EXPLANATION OF SIGNIFICANT DIFFERENCES (ESD)

RE-SOLVE, INC. SUPERFUND SITE
MANAGEMENT OF MIGRATION
OPERABLE UNIT 3

DRAFT FOR PUBLIC COMMENT

July 2015

Re-Solve Inc. Superfund Site, MOM, OU3

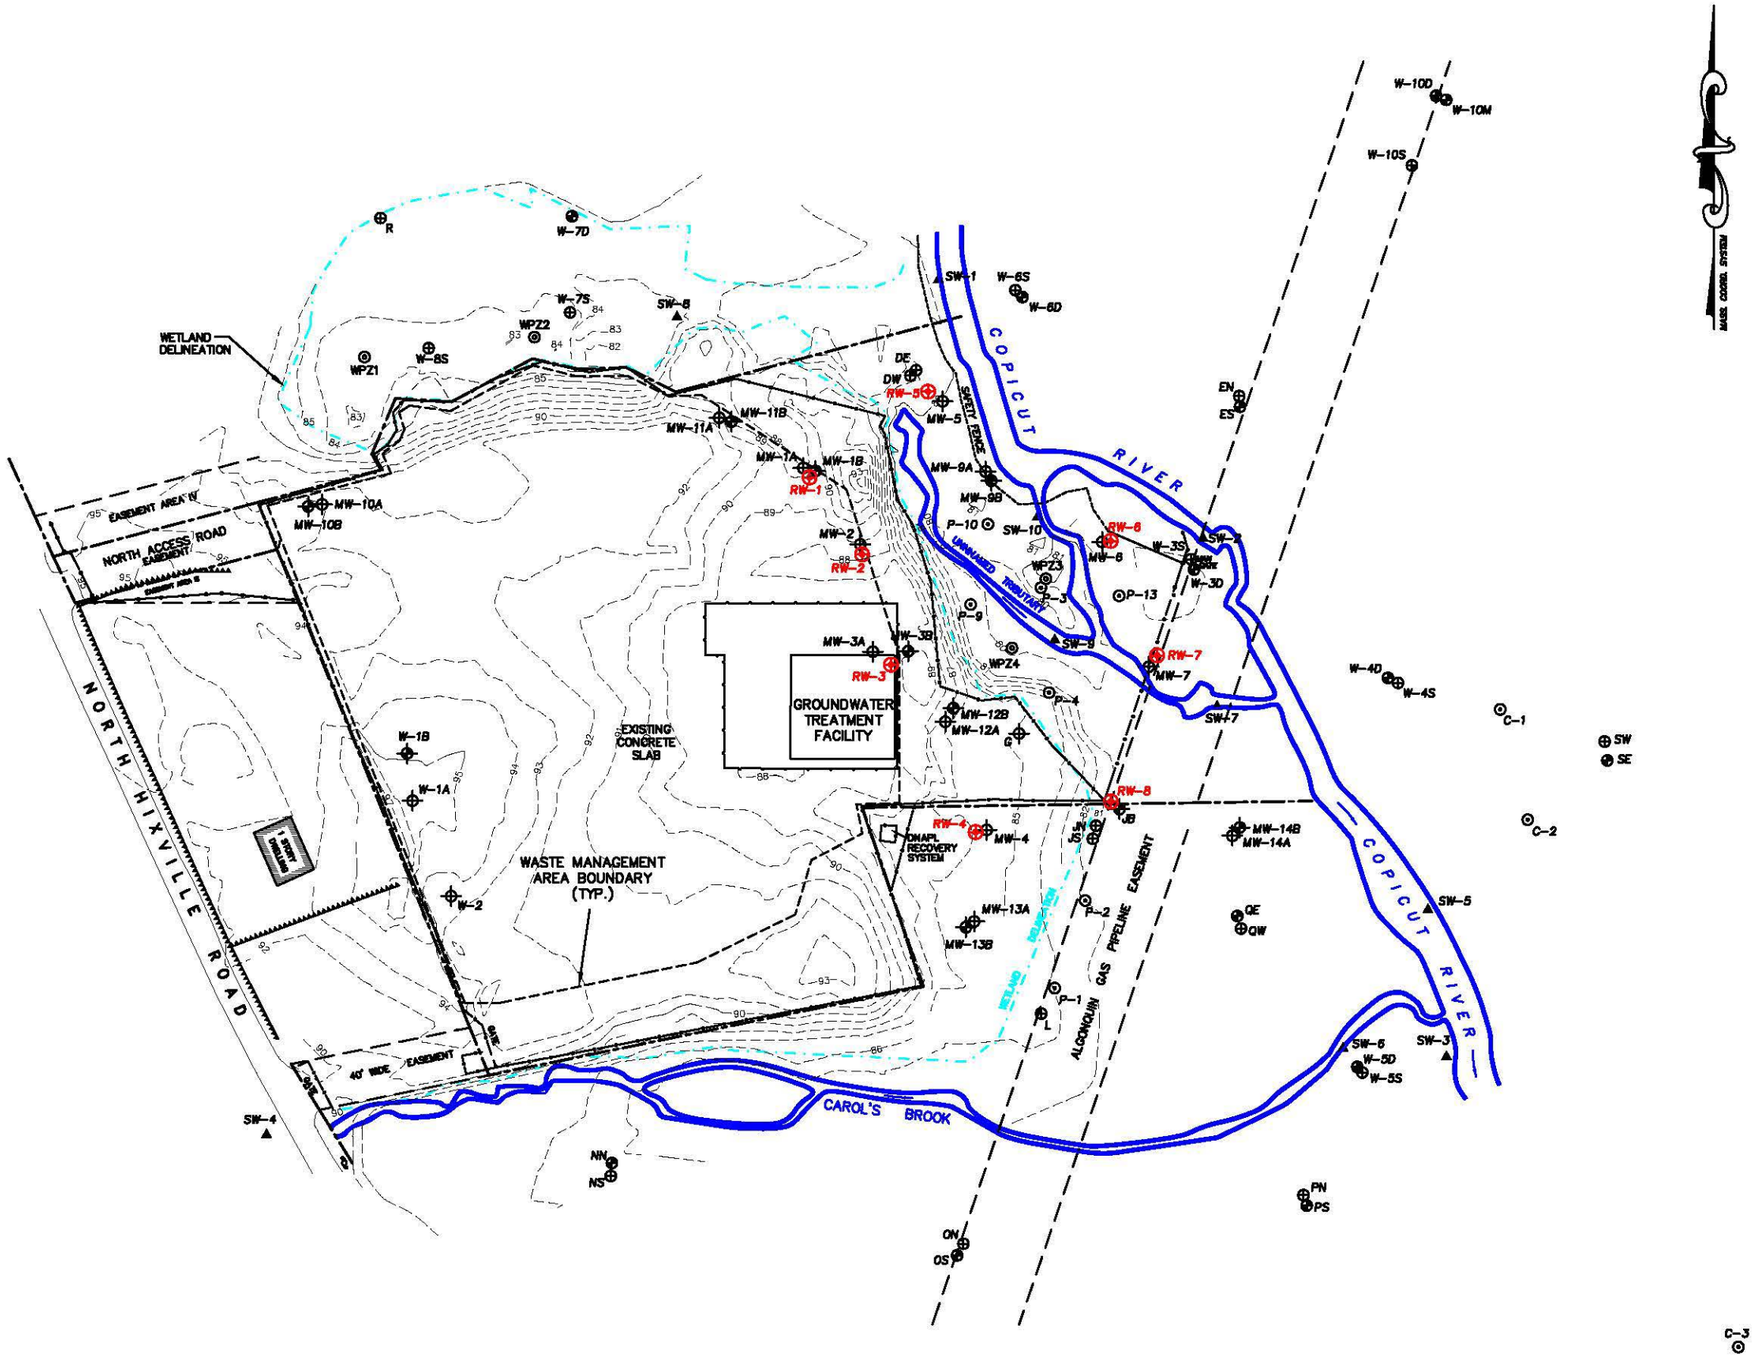
In 1996, the Management of Migration Remedial Design Implementation Plan (1996 MOM Implementation Plan (100% Remedial Design)) was completed, documenting the details for a pump and treatment system. The flushing aspect of the MOM component of the remedy was eliminated during the MOM Remedial Design process, as groundwater modeling simulations indicated that the inclusion of reinjection wells might pose a risk of remobilizing dense non-aqueous phase liquid (DNAPL) and a reevaluation for the need for soil flushing indicated that inclusion of reinjection wells would not offer significant improvements in plume capture or cleanup times. Additionally, it was determined that the bulk of contaminated soils above the seasonal groundwater low (SGL) level was excavated and treated during the Source Control component (OU2) of the remedy, further mitigating the need for flushing (1994 Intermediate (60%) Design Report, Management of Migration (60% Remedial Design), pp. 4-5 – 4-6). Therefore, all treated groundwater is discharged to surface water (i.e. Copicut River) on-site, in compliance with the substantive requirements of the Clean Water Act National Pollutant Discharge Elimination System (NPDES) regulations. In 1999, EPA documented the successful construction and operations of the MOM pump and treatment system in the Final Remedial Action Report - Management of Migration Remedial Action (1999 MOM Remedial Action Report). See Figure 2 for location of MOM Extraction and Monitoring Wells.

The 1987 ROD selected MOM target cleanup levels for certain contaminants of concern outside the boundary of the waste management area (see Figure 2 for approximate location of waste management area) based upon the Safe Drinking Water Act's Maximum Contaminant Levels (MCLs) or risk assessment:

Re-Solve Inc. MOM Treatment: Comparison of Original and ABR Enhancement

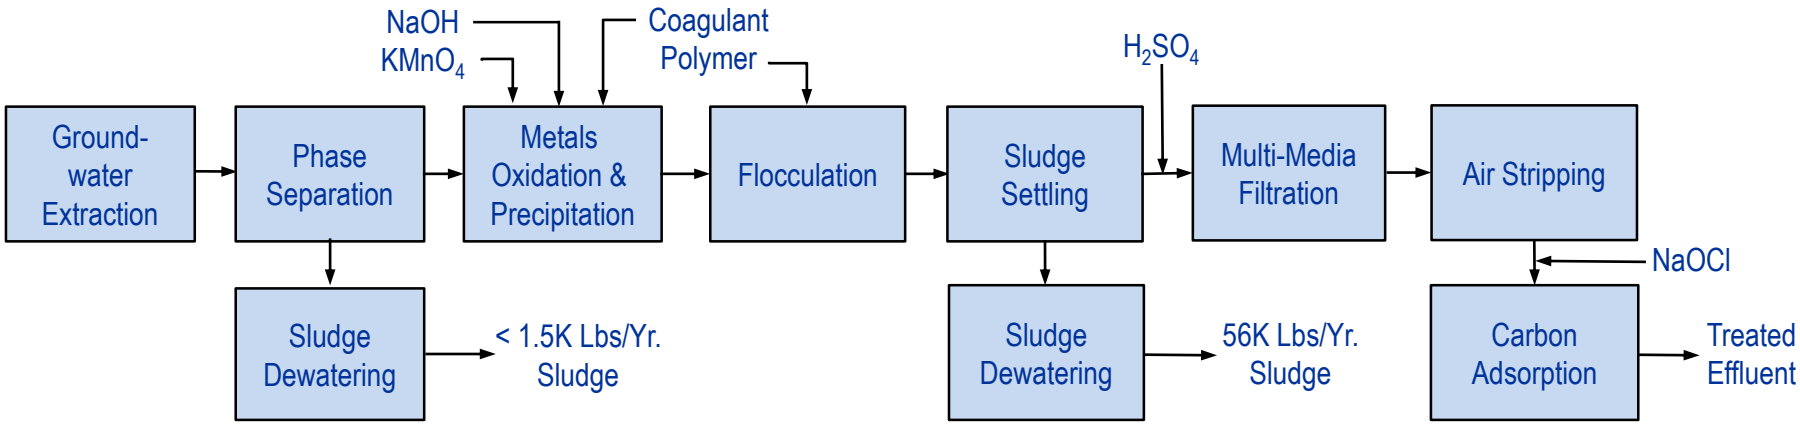
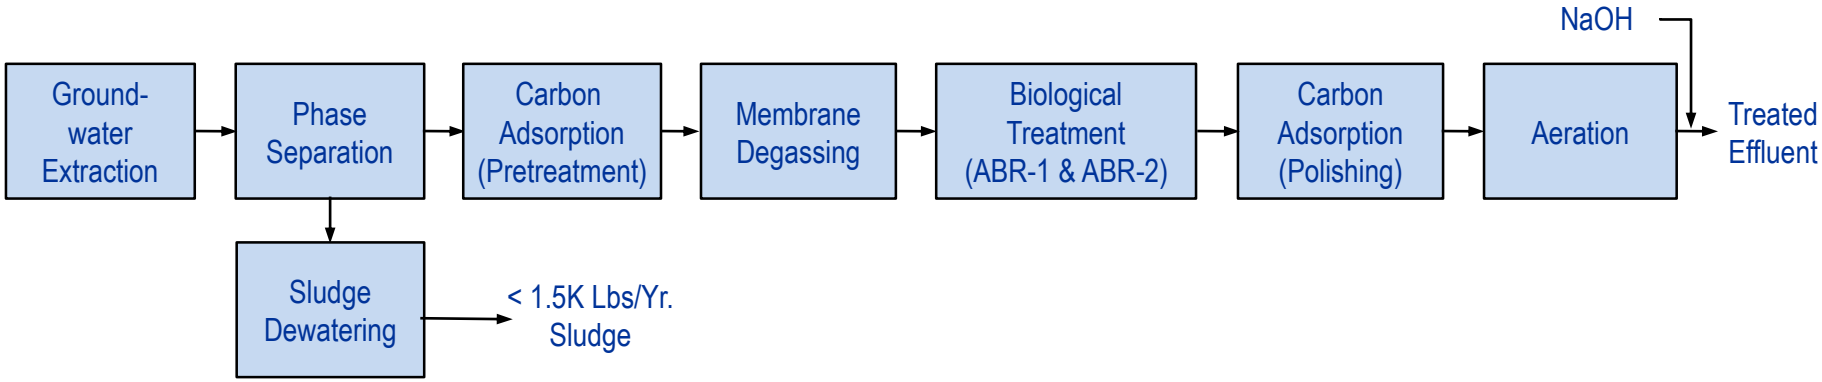
The 1987 ROD also called for extraction of contaminated groundwater from both the overburden and bedrock aquifers and treatment on-site using alternative MOM-2c Precipitation/Air Stripping/Activated Carbon/Filtration. In 1996, the MOM Implementation Plan (100% Remedial Design) was completed, documenting the details for a pump and treatment system with an air stripper and catalytic oxidizer.[1]

Since 2002, various pilot studies have been implemented at the Site to evaluate potential modifications to the MOM system to more cost-effectively achieve surface water discharge standards. In 2011, EPA agreed to allow the construction and monitoring of a full-scale pilot system, known as Anaerobic BioReactor (ABR), in accordance with the approved May 2011 "Sustainability Enhancement Design" (ABR Sustainability Enhancement Design) and associated November 2011 "Photovoltaic System" Design (Photovoltaic Design). In July 2014, the Settling Defendants[2] (known as the ReSolve Site Group) submitted a "Sustainability Enhancement Performance Report, Management of Migration, Groundwater Extraction and Treatment System" (2014 MOM Sustainability Enhancement Performance Report), documenting successful operations and monitoring of the ABR Sustainability Enhancement Design and Photovoltaic Design, as a modification to the original MOM design (1996 MOM Implementation Plan), and

The 2014 MOM Sustainability Enhancement Performance Report documents successful operation and monitoring of the ABR Sustainability Enhancement Design, which significantly reduces contaminants through the Granular Activated Carbon (GAC) and ABR treatment beds, and does not require an air stripper. As described in the 2013 FYR, "the ABR is generally a closed, passive treatment system (no air stripper) with primary VOC treatment from anaerobic degradation and GAC sorption. Each of the two beds associated with the ABR has a passive air vent. Any VOC releases from the ABR air vents would be minuscule relative to the prior [groundwater treatment plant (GWTP)] air stripper emissions which did not require treatment.…" (2013 FYR, p. 57.) Additional air monitoring in 2014 confirmed substantially reduced VOC emissions (MOM Monthly Operations Report for June 2014, dated July 23, 2014).

In May 2011, EPA agreed to allow the construction and monitoring of a full scale pilot ABR Sustainability Enhancement Design and associated Photovoltaic Design. In July 2014, the ReSolve Site Group submitted a MOM Sustainability Enhancement Performance Report documenting successful operations and monitoring of the ABR Sustainability Enhancement Design and Photovoltaic Design as a modification to the original MOM design, and the achievement of surface water discharge standards. The ABR Sustainability Enhancement Design significantly reduces contaminants through the GAC and ABR treatment beds, and does not require an air stripper.

- The anoxic influent from the eight extraction wells is processed through the phase separator and influent tank, where solids are drained to the sludge holding tank and dewatered (component of original groundwater treatment system).

- The low dissolved oxygen levels are maintained throughout the system until aeration and discharge.
- The process water is pumped from the influent tank to the two 10,000-pound pre-treatment carbon vessels (components of original groundwater treatment system) to primarily remove PCBs.

- The process water flows through a degassing membrane system to reduce total dissolved gasses before entering the ABR 1 and 2 beds. The ABR 1 and 2 beds are two self-contained, subsurface beds filled with a sand-peat media designed to anaerobically degrade VOCs in the process water (via reductive dechlorination process). During months when the groundwater influent from the extraction wells are coldest, heat is applied to the process water before entering the ABR beds for maintaining healthy anaerobic conditions.

- The process water then travels through two 5,000-pound polishing carbon vessels to provide further assurance of compliance with the discharge limits in the event of a system upset.
- Final aeration steps/columns and pH adjustments achieve appropriate surface water dissolve oxygen and pH levels for surface water discharge.

1. Elimination of the reinjection/flushing component of the MOM remedy, and the consequent change from discharging a small portion, or approximately 5 to 10 gallons per minute, to discharging all treated groundwater to surface water on-site.
2. Modification of the method to remove the contaminated groundwater's VOCs from air stripping to the ABR Sustainability Enhancement Design and the associated Photovoltaic Design.
3. Selection of target cleanup levels for additional contaminants of concern (including 2 ppb for vinyl chloride, 7 ppb for 1,1-dichloroethylene, and 75 ppb for p-dichlorobenzene) and change of the target cleanup level for lead from 50 ppb to 15 ppb.
